Subject: VARIOUS ELECTRICAL SYSTEM MALFUNCTION(S) RELATED TO C-15 CONNECTOR CORROSION	Bulletin No: 09-005/14
	Last Issued: 01/14/2014

2013-2014 CX-5 vehicles with VINs lower than JM3KE*****365953 (produced before June 25, 2013)

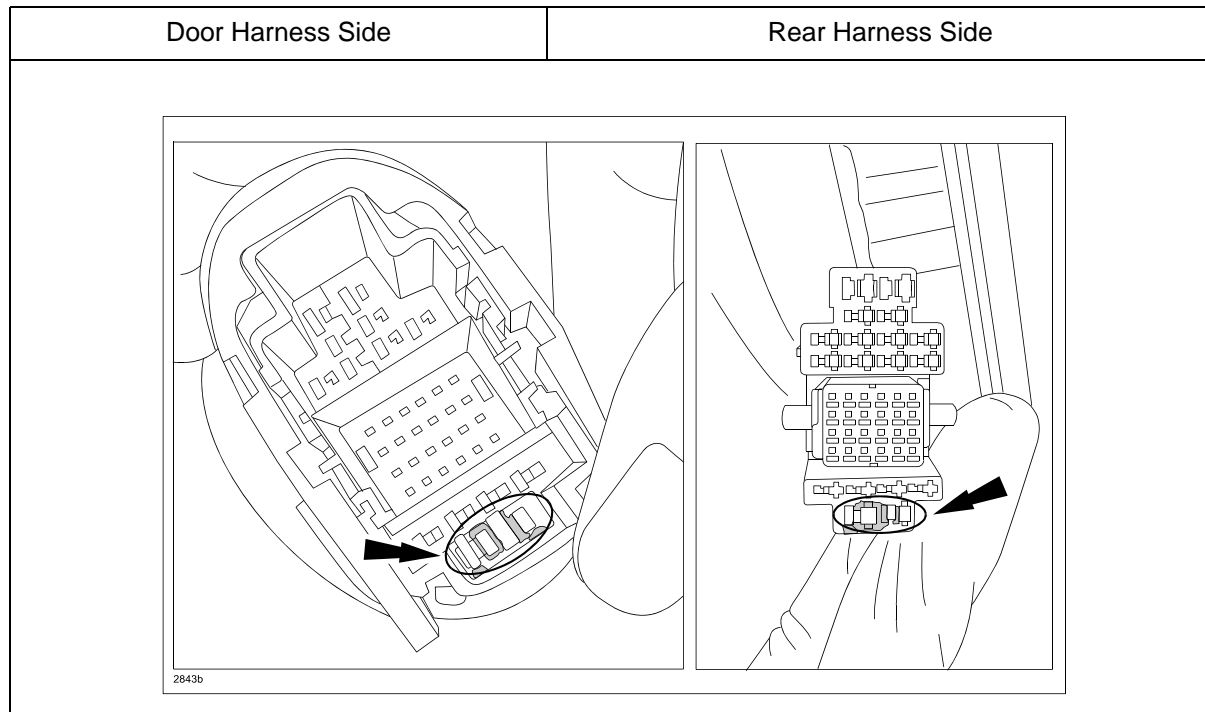
MASS PRODUCTION CHANGES:

- The front door harness grommet has been changed to improve sealing performance.
- Holes inside the front pillar (which are made for weight reduction), have been covered to prevent water intrusion.
